**Design Review Board Case #2012-0002**  
**Carlyle Plaza Two – South Residential Building**

<p><b>DRB ACTION, NOVEMBER 19, 2012:</b> The DRB reviewed the initial concept for this block and provided feedback on the liner units and the tower massing. The DRB will continue to review the plans for this development at the next meeting.</p>

*Approved Concept Plan (June 2012)*

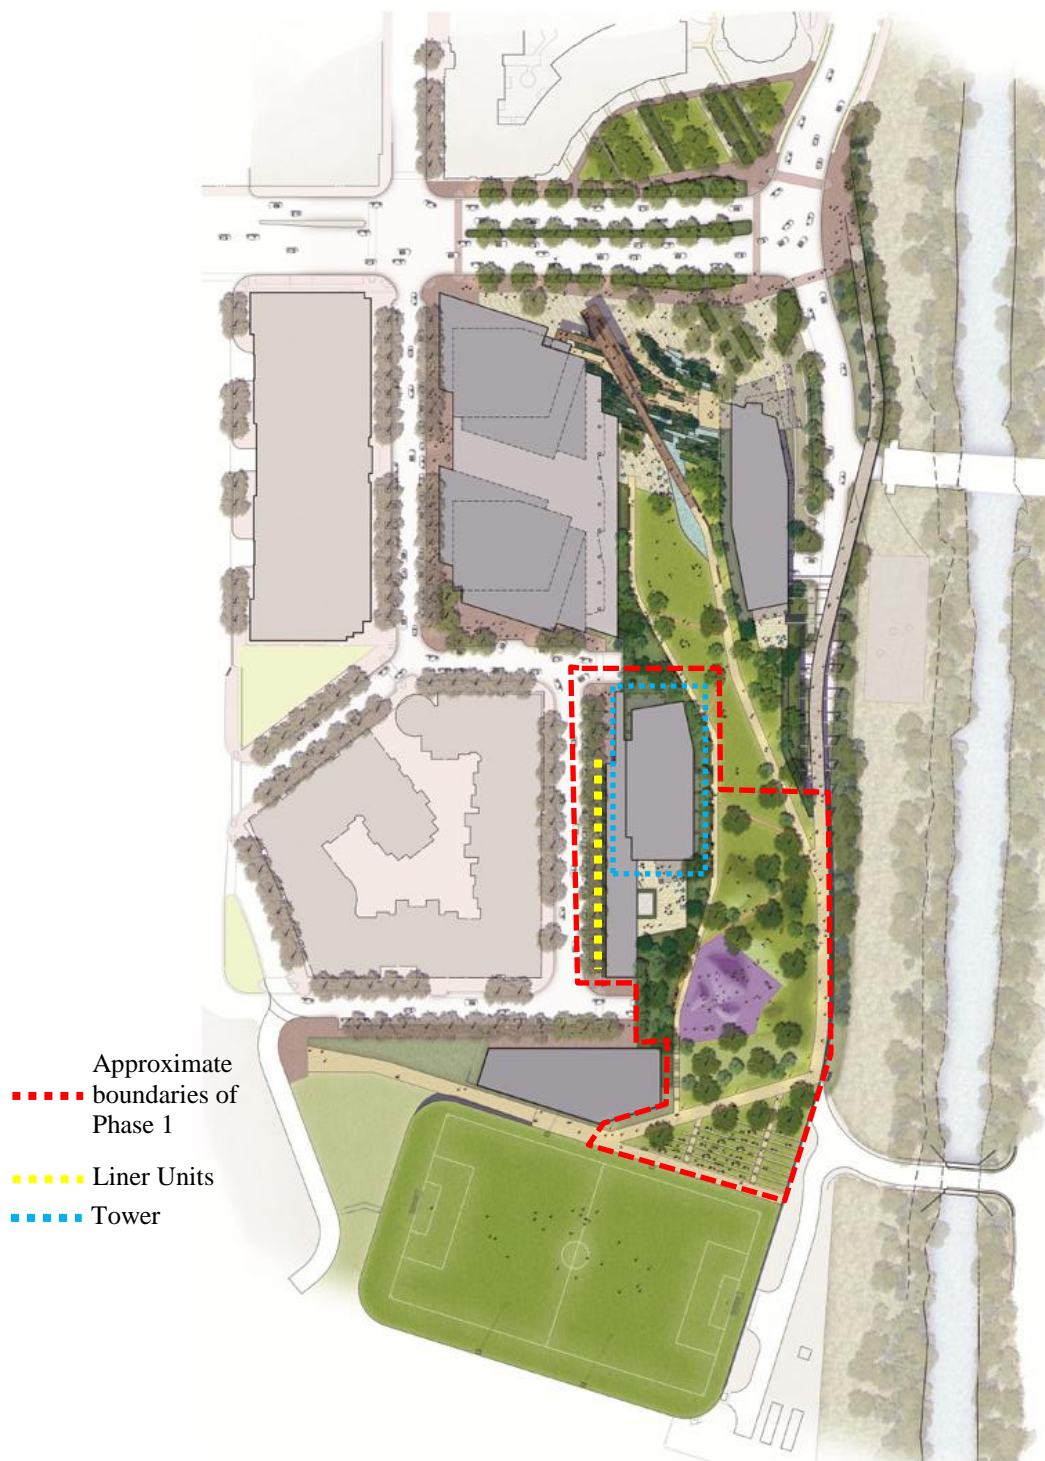
One area that could benefit from additional study is the massing of the southern element. Staff suggests returning to the more angular/less boxy footprints as shown in the approved concept plan by narrowing the south end of the building and introducing slightly angular forms, which would in turn better relate the tower footprint to the subtle angles used in the landscaped deck and pathways. This would also give the south elevation a more delicate and refined appearance. Additionally, the relationship between the tower, the liner units, and the Savoy Street garage entrance at the ground level needs to be carefully studied to provide a pleasant pedestrian experience. Future submissions should include more detail about the treatment of this area.
